APPLICATION NO.	FILING DATE	FIRST NAMED INVENTOR	ATTORNEY DOCKET NO.	CONFIRMATION NO.
10/760,168	01/16/2004	Travis M. Perkins	US20020232-2	2927

Office Action Summary	Application No.	Applicant(s)
	10/760,168	PERKINS ET AL.
	Examiner	Art Unit
	Jennifer E. Novosad	3634

DETAILED ACTION

Proposed Drawg.
Correction Approved
- 9/25/06

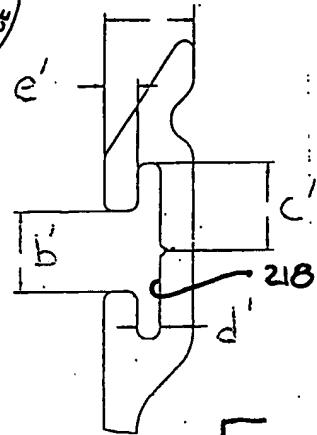
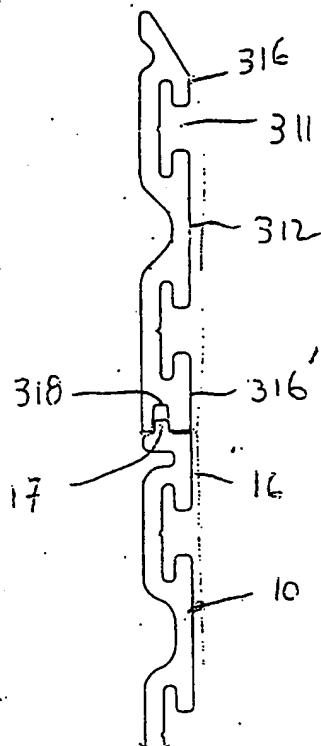
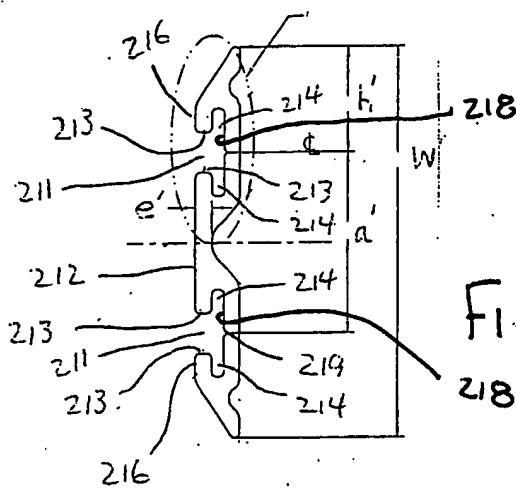
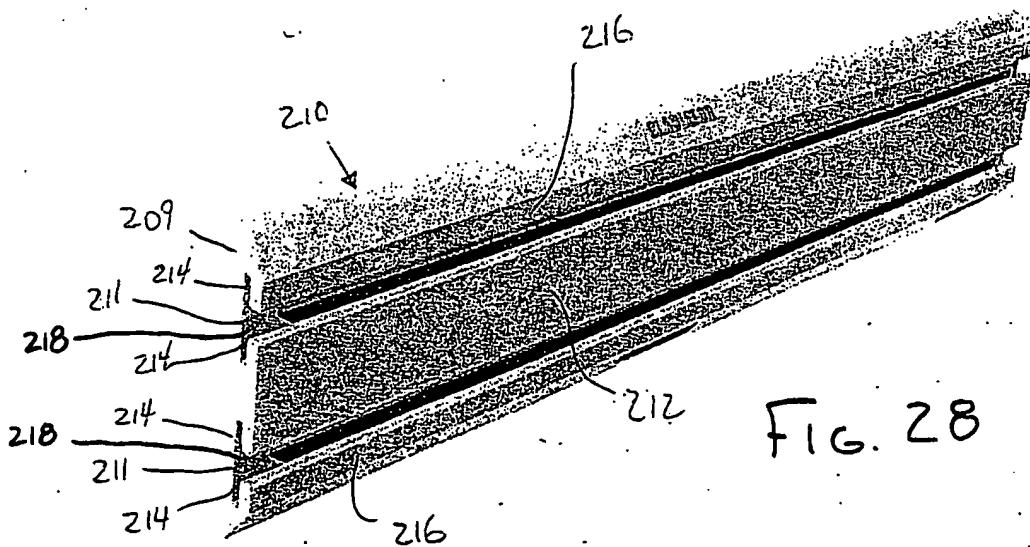
The drawing containing corrections were received on August 21, 2006. These drawings are approved.
